TECHNICAL ADDENDUM

Addendum No. 01

**Expansion and Redevelopment of the
North Portal Port of Entry
North Portal, Saskatchewan**

Project No./No. du projet R.065684.001	Sheet/Feuille SK-C01 OF	Revision no./ La Révision no. A
--	--------------------------------------	--

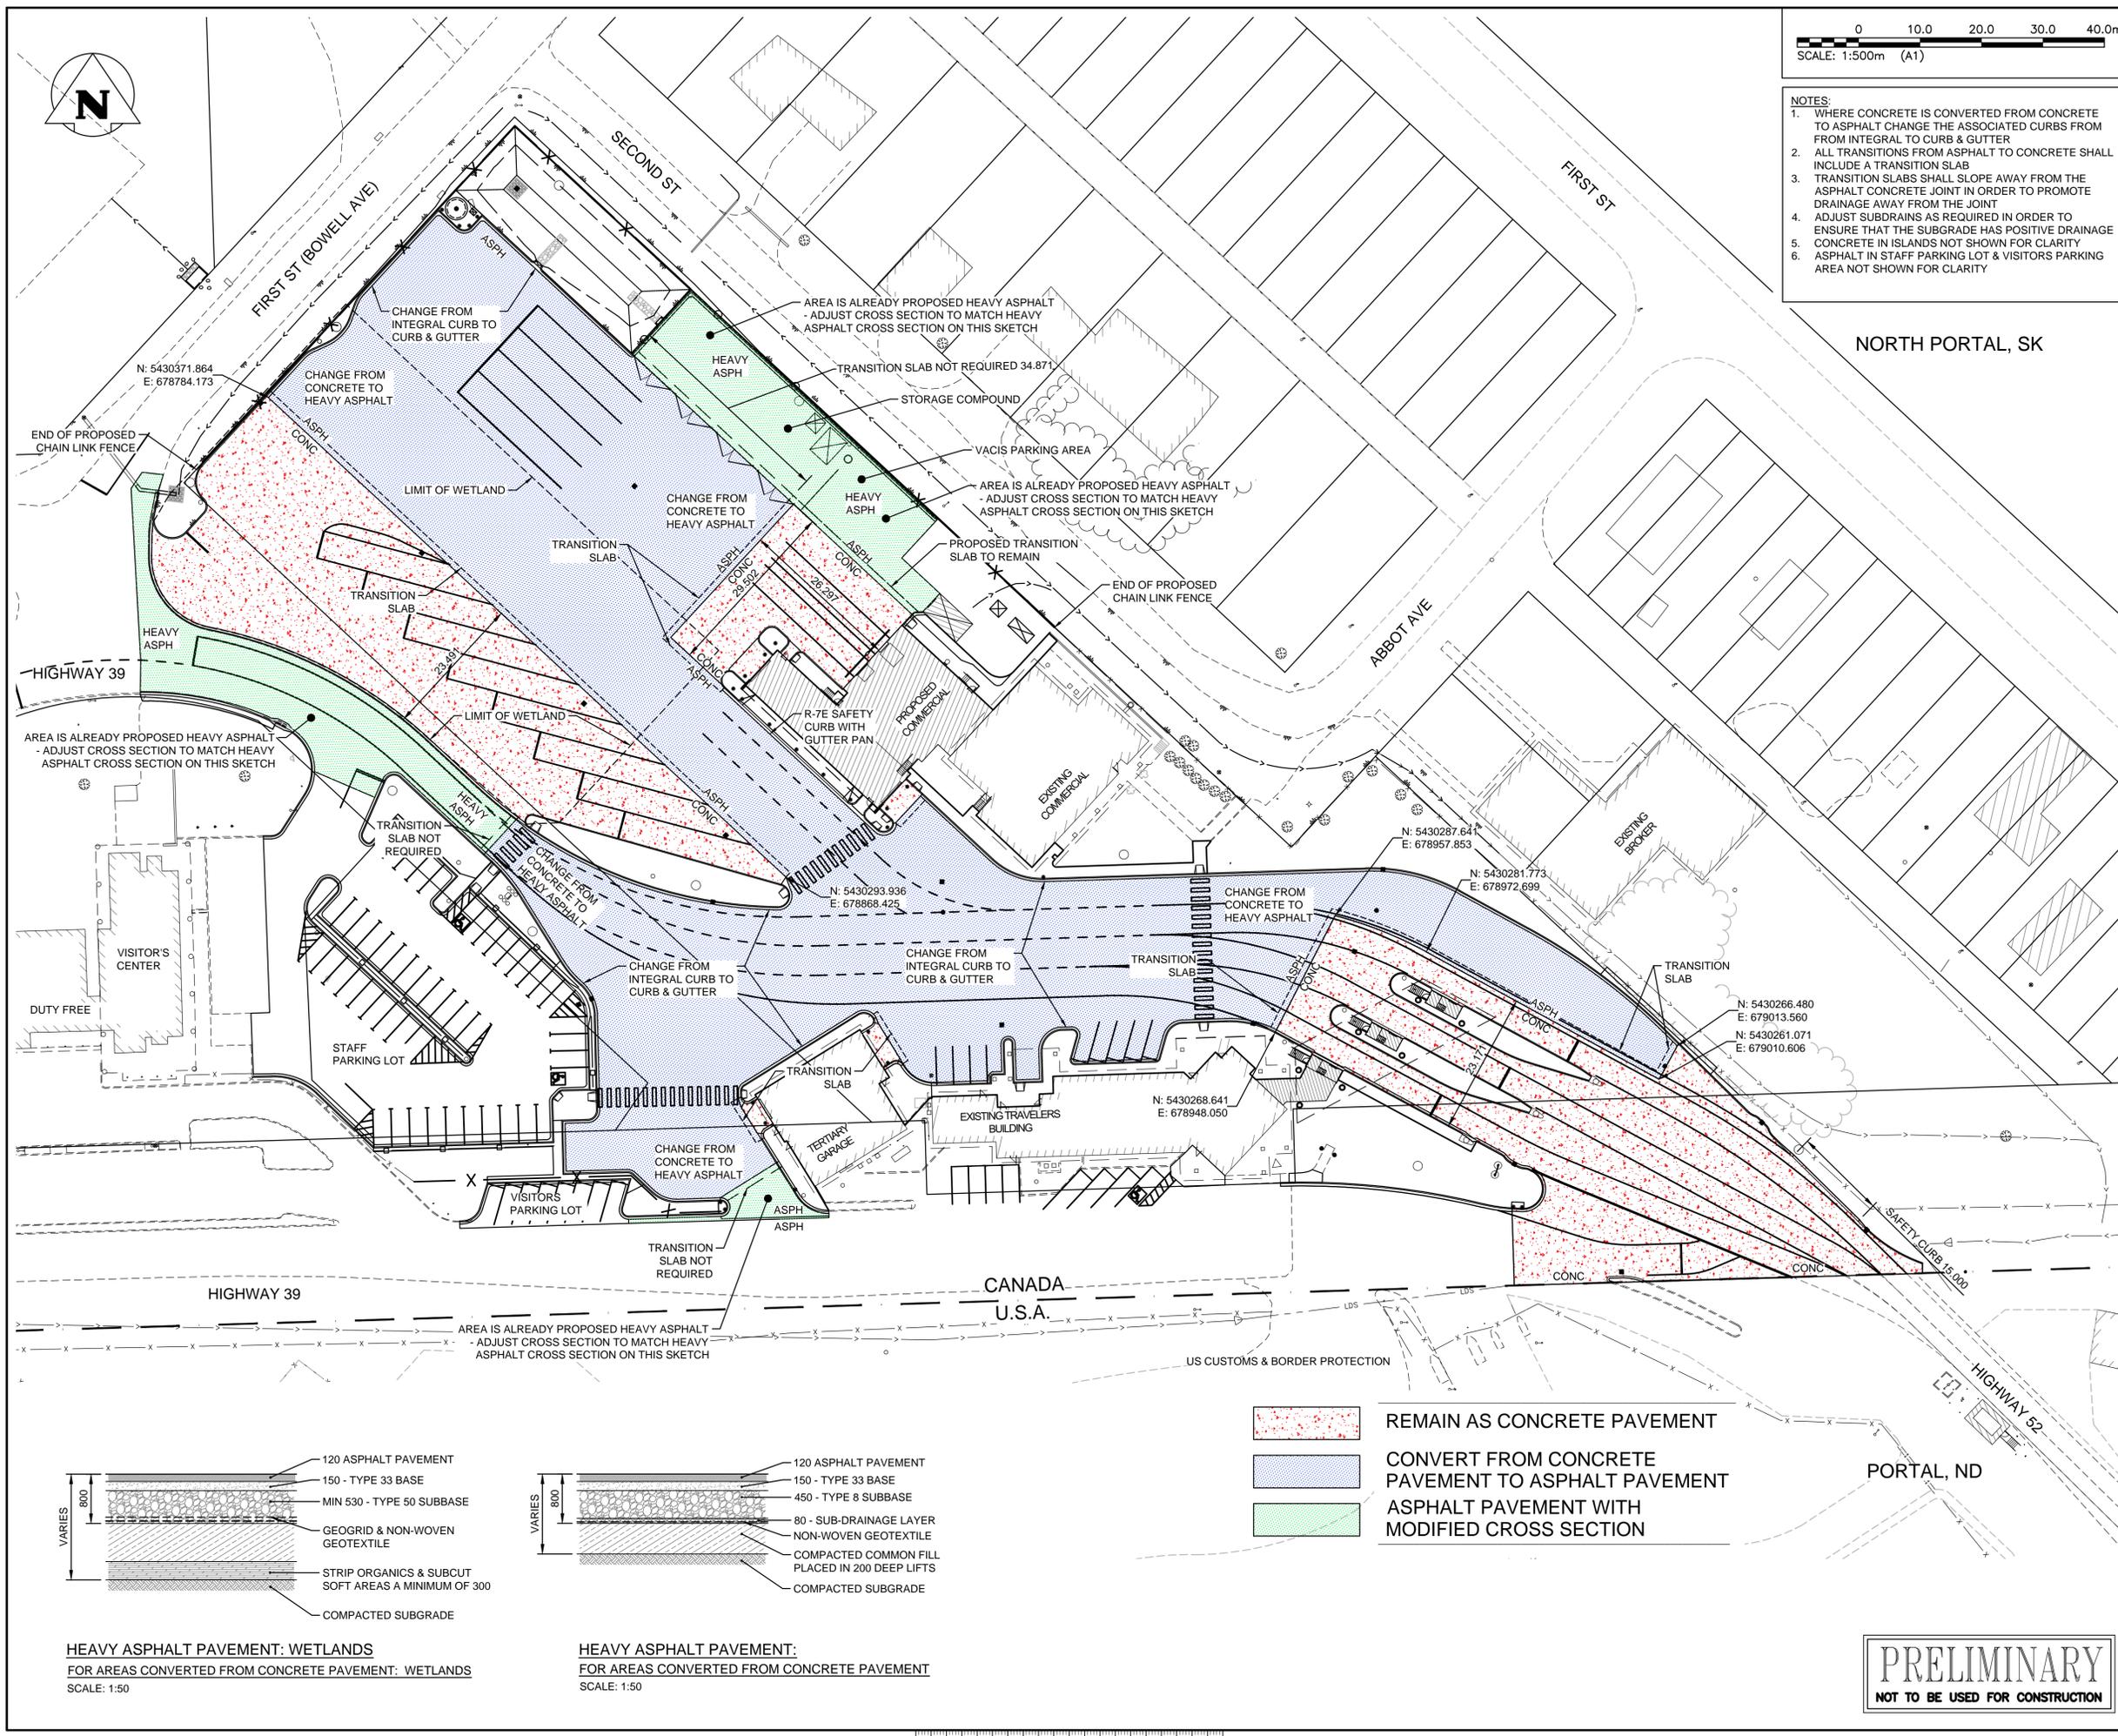
1. Refer to attached sketch SK-C01:
Sketch SK-C01 indicates changes to the pavement cross sections at the North Portal: Port of Entry site.
 - a. Select areas of pavement are to be converted from Concrete Pavement to Heavy Asphalt Pavement.

- b. Select areas of the pavement type change are within the wetland limits and require additional sub-base work.
 - c. Proposed surface grades do not change except for some minor adjustments at transitions from concrete to asphalt to better align with grade breaks.

- d. Due to the change in pavement type the Contractor shall note the following changes to the various other components of the site, such as:
 - i. Adjusted cross sections provided on SK-C01 indicating modifications to the sub-base thickness.

- ii. Where concrete is converted to asphalt the Contractor shall change the associated curb from integral curb to curb & gutter.
 - iii. All transitions from asphalt to concrete shall include a transition slab that will slope away from the asphalt / concrete joint in order to promote drainage away from the joint.

- iv. Shape the subgrade and adjust the locations of sub drains as required to ensure that the subgrade has positive drainage to the low points.
 - v. Changes to the limits of concrete will require modifications to the saw cuts for the concrete pavement work.

- NOTES:**
1. WHERE CONCRETE IS CONVERTED FROM CONCRETE TO ASPHALT CHANGE THE ASSOCIATED CURBS FROM INTEGRAL TO CURB & GUTTER
 2. ALL TRANSITIONS FROM ASPHALT TO CONCRETE SHALL INCLUDE A TRANSITION SLAB
 3. TRANSITION SLABS SHALL SLOPE AWAY FROM THE ASPHALT CONCRETE JOINT IN ORDER TO PROMOTE DRAINAGE AWAY FROM THE JOINT
 4. ADJUST SUBDRAINS AS REQUIRED IN ORDER TO ENSURE THAT THE SUBGRADE HAS POSITIVE DRAINAGE
 5. CONCRETE IN ISLANDS NOT SHOWN FOR CLARITY
 6. ASPHALT IN STAFF PARKING LOT & VISITORS PARKING AREA NOT SHOWN FOR CLARITY
